REFERENCE: PARKSIDE YERONGA – SOCIAL AND AFFORDABLE HOUSING**PREAMBLE**

A subsequent DA (DEV2023/1367) was submitted to EDQ-DA for a residential development (Proposed Lot 3). EDQ-DA has reviewed the submission and issued a Further Issues letter (via email, dated 16 March 2023) which included a number of traffic and transport related items.

Reference: PARKSIDE YERONGA – SOCIAL AND AFFORDABLE HOUSING PROPOSAL (FURTHER ISSUES LETTER RESPONSE)

DRAWING
PLANS BASEMENT PLAN

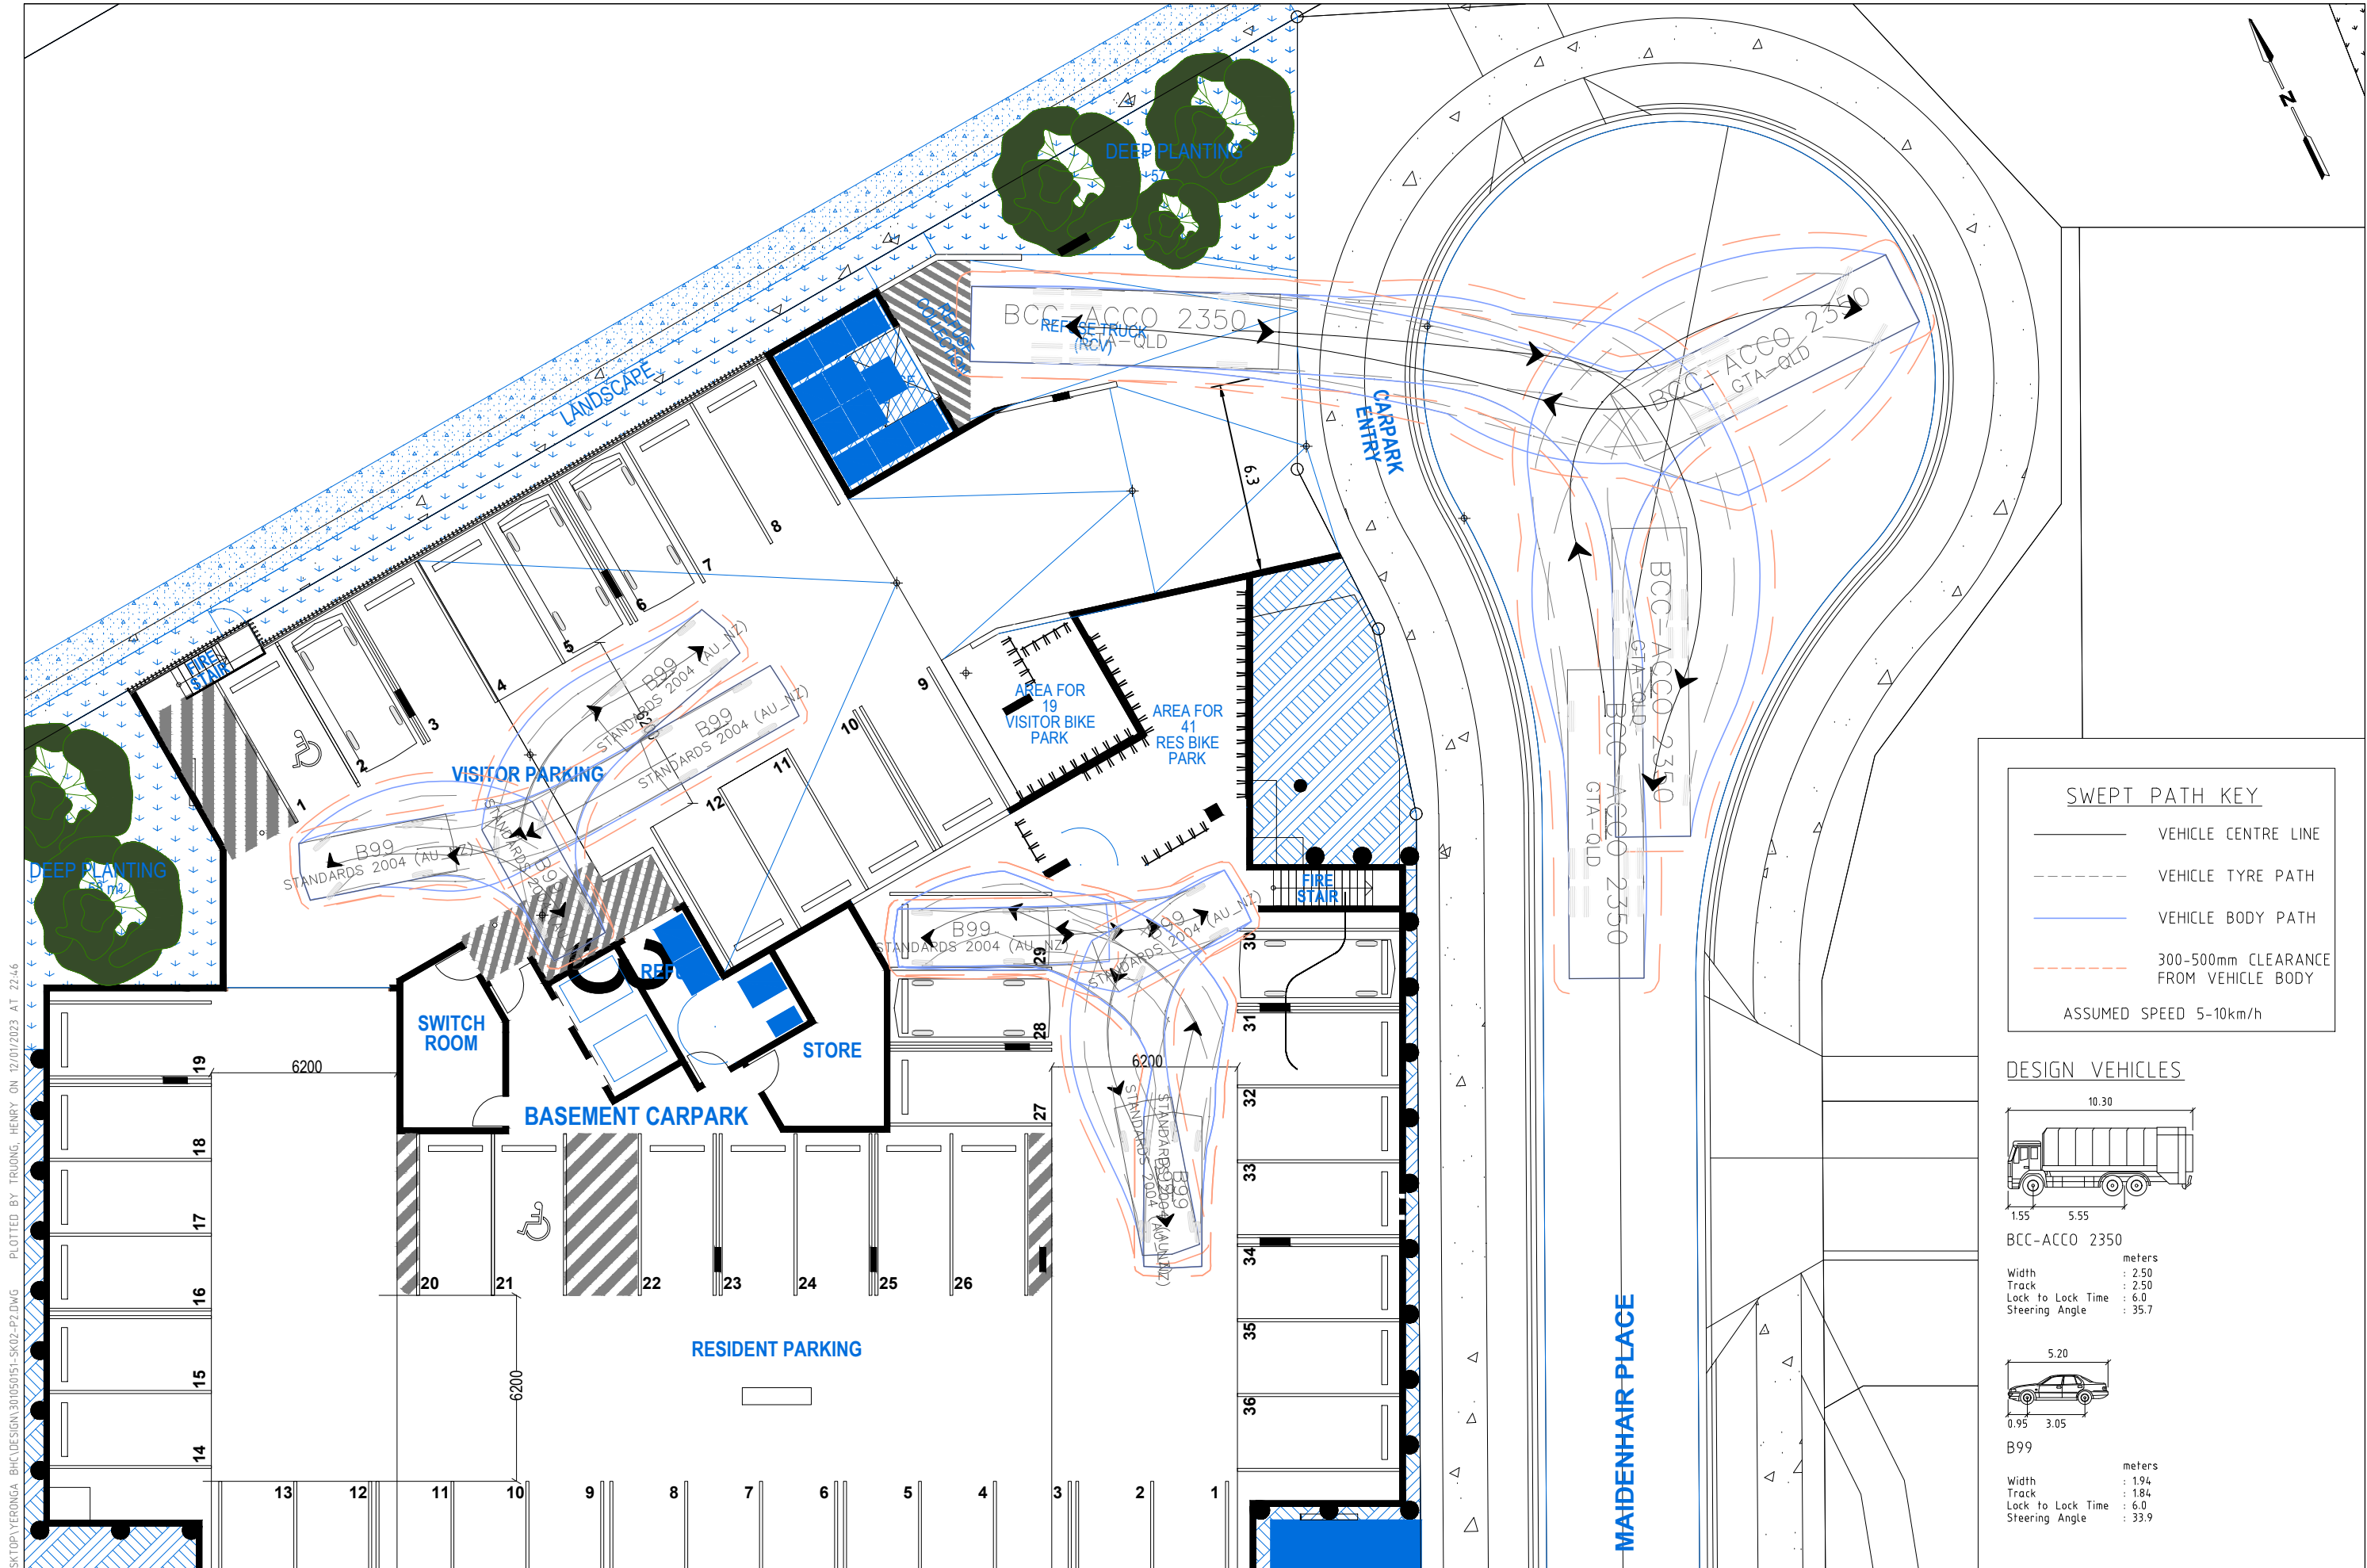
"Sufficient information has not been provided for EDQ to assess the standards for the car parking proposed. Provide dimensioned plans which demonstrate:

- *that sufficient vertical clearance is achieved for all parking spaces in the basement (include PWD spaces);*
- *structural elements are within the parking spaces envelopes, and all walls are greater than 0.3m from the edge of parking spaces in accordance with BCC TAPS PSP; and*
- *compliance with BCC TAPS PSP as much as practicable."*

The architectural package has been revised to provide a detailed basement level layout drawing (drawing SK 202 revision B, dated 17 April 2023, provided in Attachment A) which includes dimensions and vertical clearances throughout the basement.

The proposed development layout is provided generally in accordance with Council's TAPS PSP where practicable, with Performance Solutions adopted and clearly identified in accordance with relevant Australian Standards. An updated car parking layout review (including vertical clearances) has been undertaken against the requirements of Council's TAPS PSP, relevant Australian Standards (AS2890.1 and AS2890.6) and good transport engineering practice. Details of this review are provided below in Table 3.
